FACPAC Contract Change Order Supplemental Information Form (Ref# 62045)

Tier 1 Project: New Child Nutrition Facility

Change Order Number 3
Time Extension Required No

Hardin County School Child Nutrition Facility Change Order #1 - MEP 01/27/25

Item #2 Refer to the drawings, Sheet E601 – ONE LINE DIAGRAM

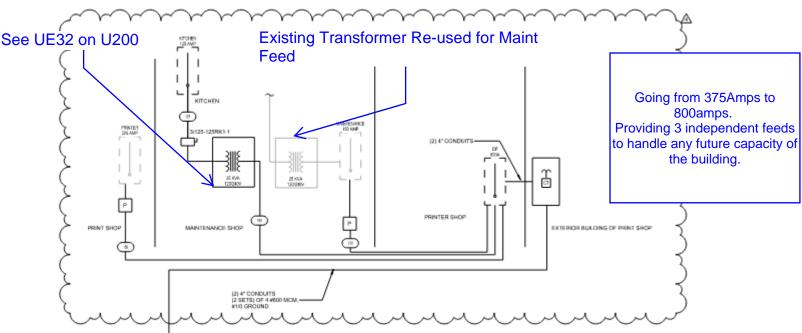
A. Refer to snippet below for revised one line diagram with new CT cabinet and distribution panel.
